SUBJECT: Forwards revised FSAR figures documenting analyses of SER
 Confirmatory Issue 1 re final pipe break locations & design
 of pipe whip restraints. Final break locations based on
 completion of as-built programs & final stress analysis.

Subject: NUCLEAR PROJECT NO. 2
SAFETY EVALUATION REPORT, CONFIRMATORY
ISSUE (1) BREAK LOCATIONS

The subject confirmatory issue requires submittal of the results of analyses to determine final pipe break locations and final design of pipe whip restraints. Attached are the revised FSAR figures documenting these analyses. It should be noted that these revisions indicate break locations based on the "status as built" stress analysis with thermal and fatigue loads. The "status as built" is not a final "as built" configuration; however, the Supply System does not anticipate any significant differences. Hence, the stress analysis and resulting pipe break locations in the attached figures, although not based on a final "as built", will not differ significantly from the final break locations. The final break locations will be based on completion of the "as built" program and the final stress analysis. Although no changes are anticipated, the Supply S

FIGURE
C-302

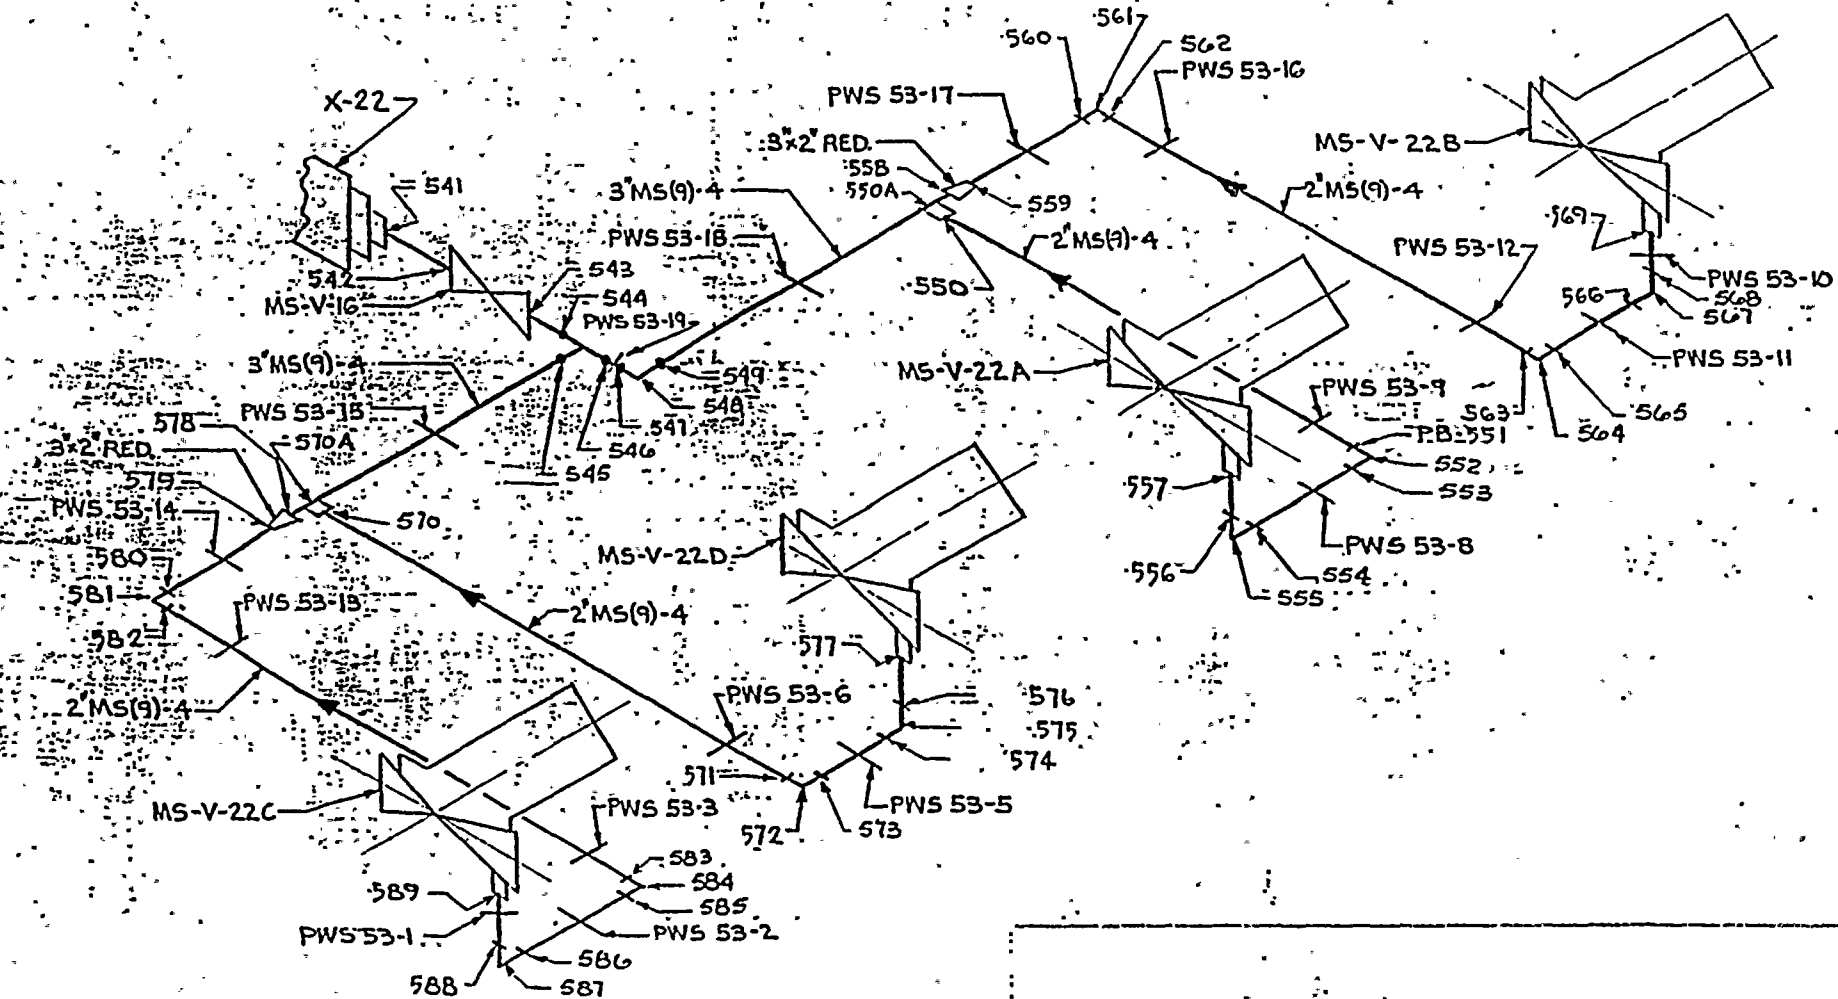
LONGITUDINAL BREAKS

~~Node 194~~
~~Node 195~~
~~Node 197~~
~~Node 198~~
~~Node 200~~
~~Node 201~~
~~Node 202~~
~~Node 203~~
~~Node 205~~
~~Node 206~~
~~Node 208~~
~~Node 209~~
~~Node 211~~
~~Node 211A~~
~~Node 212~~
Node 212A
Node 214
~~Node 214A~~
~~Node 214B~~
~~Node 214C~~
~~Node 214D~~
~~Node 214E~~
~~Node 214F~~
~~Node 214G~~
~~Node 214H~~
~~Node 214I~~
~~Node 214J~~
~~Node 214K~~
~~Node 214L~~
~~Node 214M~~
~~Node 214N~~
~~Node 214O~~
~~Node 214P~~
~~Node 214Q~~
~~Node 214R~~
~~Node 214S~~
~~Node 214T~~
~~Node 214U~~
~~Node 214V~~
~~Node 214W~~
~~Node 214X~~
~~Node 214Y~~
~~Node 214Z~~
~~Node 215~~
~~Node 216~~
~~Node 217~~
~~Node 218~~
~~Node 219~~
~~Node 220~~
~~Node 221~~
~~Node 222~~
~~Node 223~~
~~Node 224~~
~~Node 225~~
~~Node 226~~
~~Node 227~~
~~Node 228~~
~~Node 229~~
~~Node 230~~
~~Node 231~~
~~Node 232~~
~~Node 233~~
~~Node 234~~
~~Node 235~~
~~Node 236~~
~~Node 237~~
~~Node 238~~
~~Node 239~~
~~Node 240~~
~~Node 241~~
~~Node 242~~
~~Node 243~~
~~Node 244~~
~~Node 245~~

~~Node 196~~
~~Node 199~~
~~Node 201A~~
~~Node 204~~
~~Node 207~~
~~Node 210~~
Node 213

FIGURE
3.6-32a

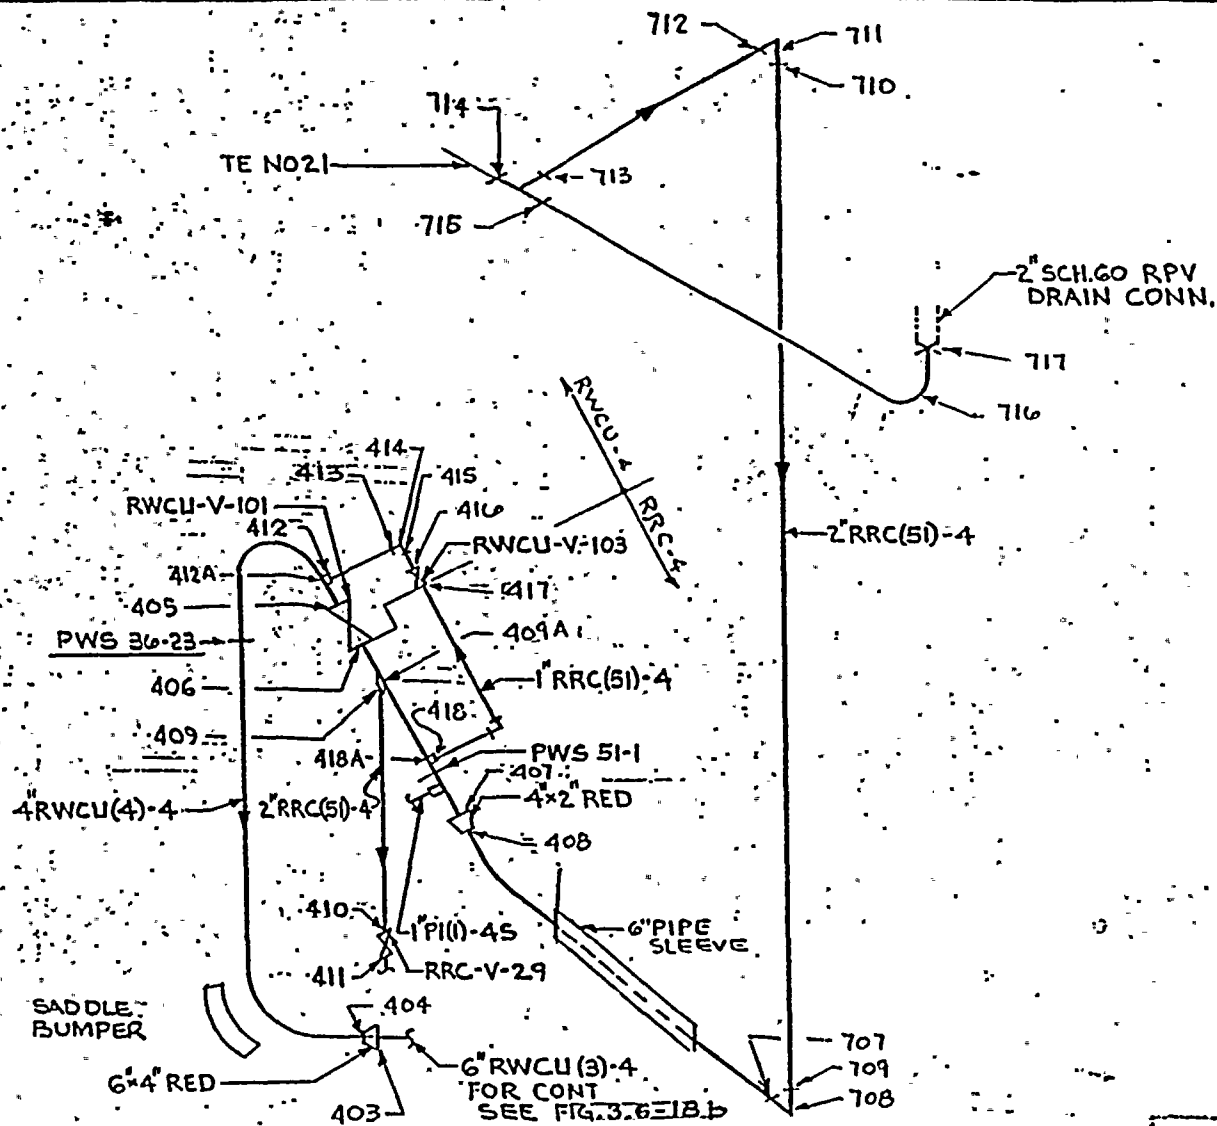
SUMMARY OF POSTULATED PIPE BREAK LOCATIONSCIRCUMFERENTIAL BREAKS

Node 663 •
~~Node 664~~
~~Node 666~~
~~Node 666A~~
~~Node 666B~~
~~Node 667~~
Node 668 •
~~Node 669~~
~~Node 670~~
~~Node 671~~
~~Node 672~~
~~Node 673~~
~~Node 674~~
~~Node 675~~
Node 675A •
Node 675B •
NODE 666C

Node 676 •
Node 677 •
Node 678 •
Node 679 •
~~Node 680~~
~~Node 681~~
Node 683 •
~~Node 687~~
~~Node 689~~
Node 690 •
~~Node 692~~
~~Node 694~~
Node 695 •
~~Node 696~~
~~Node 697~~
~~Node 698~~
NODE 682A
NODE 682C
NODE 682D
NODE 682F
NODE 682G
NODE 682I
~~NODE 683~~
NODE 683A
NODE 683B
NODE 683C
